ENGINEER'S SEAL	LOT 12 THE SAUVIGNON SUBDIVISION	DRAWN BY WCUJ
	GRADING AND DRAINAGE PLAN	DATE 4-26-12
	 <i>Rio Grande Engineering</i> 1606 CENTRAL AVENUE SE SUITE 201 ALBUQUERQUE, NM 87108 (505) 872-0899	21212-LAYOUT-4-26-12
DAVID SOULE P.E. #14522		SHEET #  HYDROLOGIST # SECTION 21212

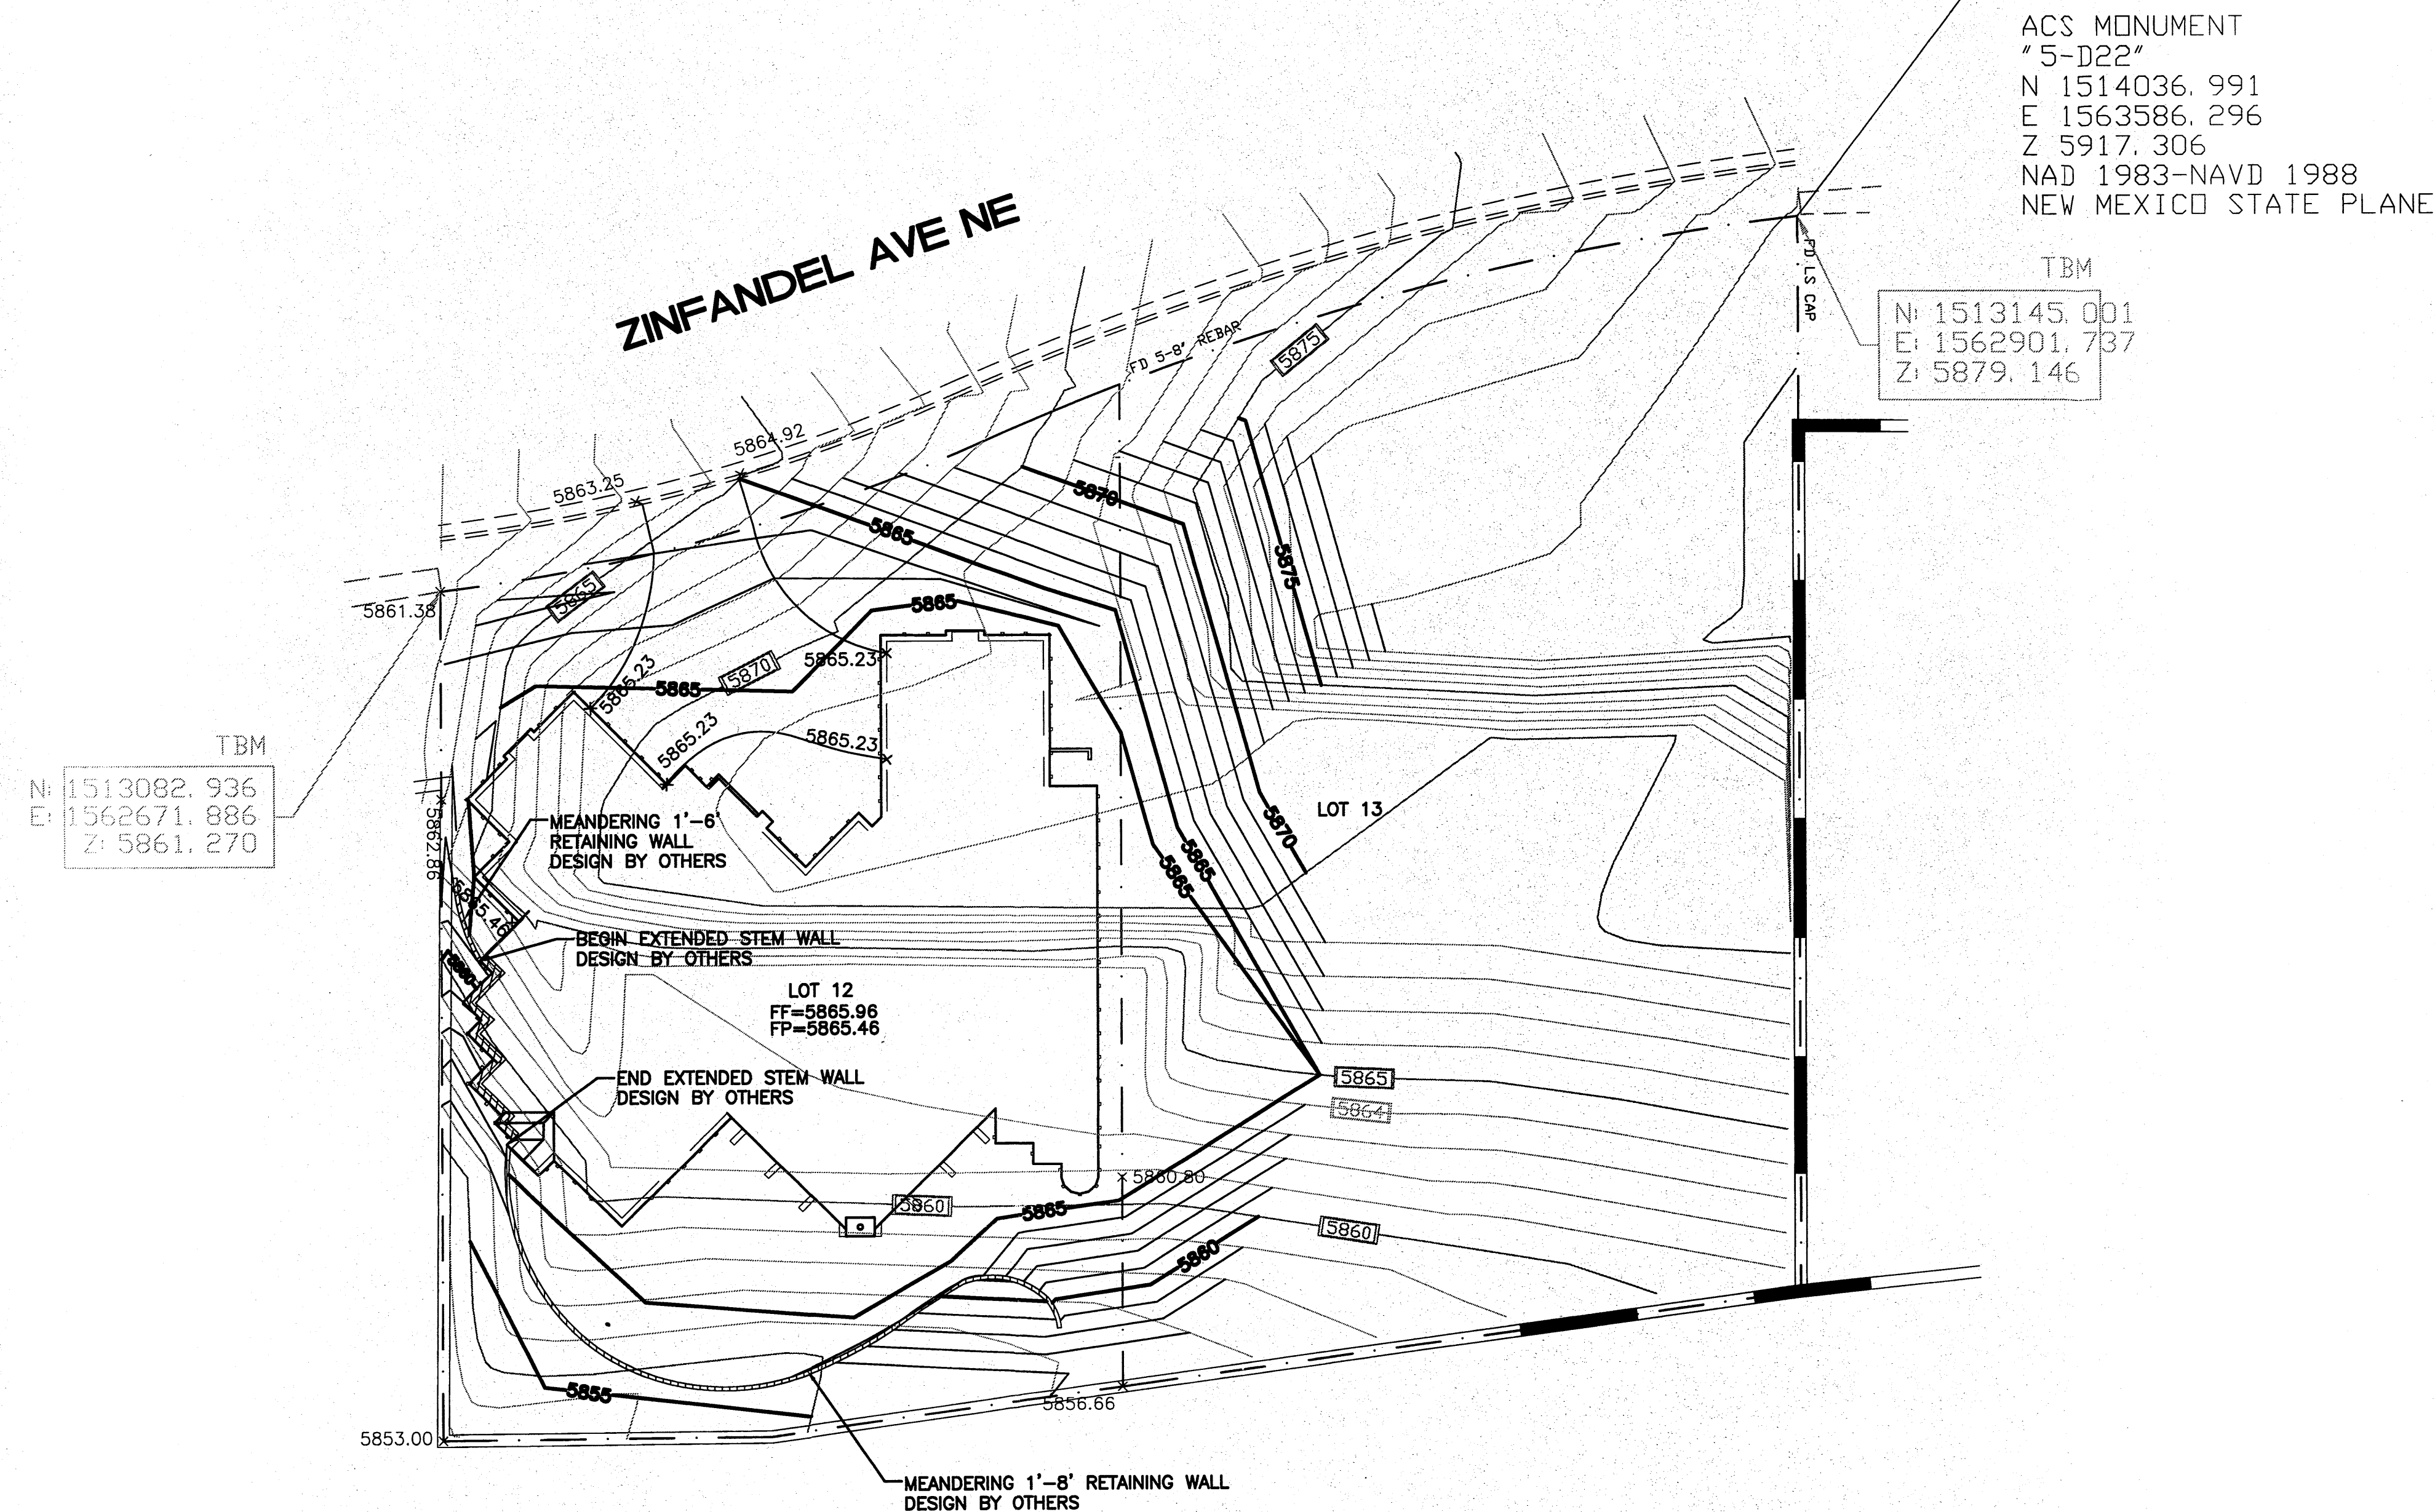
- ① - Provide copy of the master drainage plan
- ② - Provide the written approval, make sure letter mentions the impact on already graded parts
- ③ - Provide calc's
